TOWN OF DAVIE TOWN COUNCIL AGENDA REPORT

SP 3-4-02, Andrx - Building Elevation Modification - 4955 Orange Drive, Generally located on the northeast corner of Orange Drive and Kean Road.

TITLE OF AGENDA ITEM: Andrx - Building Elevations Modification

Review of Project Landscape & Maintenance

Site Plan Committee

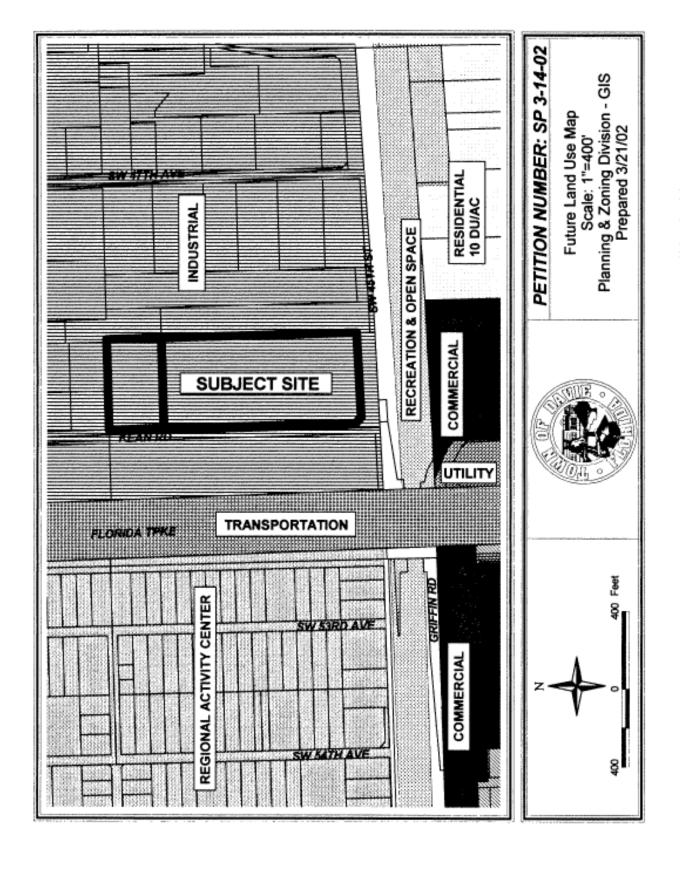
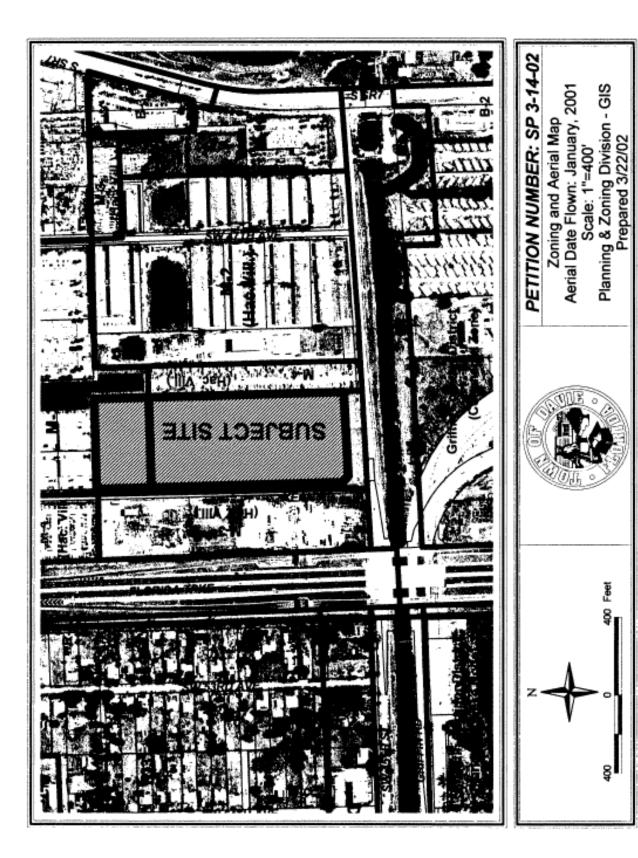
<u>Site Plan Committee Recommendation:</u> Motion to approve based on the planning report and based on that Andrx has the landscape plan recertified by Mr. Thomas Laubenthal or and equal such as a

certified arborist or a landscape architect; that all deficiencies in the landscape plan must be corrected before issuing a building permit; that the job was to look like the original landscape plan with the new revisions including the wetlands; that after the work has been completed, it was to be inspected by the Town of Davie; and after the inspection, they could get a permit for this additional modification (Motion By: Vice-Chair Aucamp, Seconded By: Mr. Crowley, Motion carried: 4-0, Mr. Engel absent, May 7, 2002).
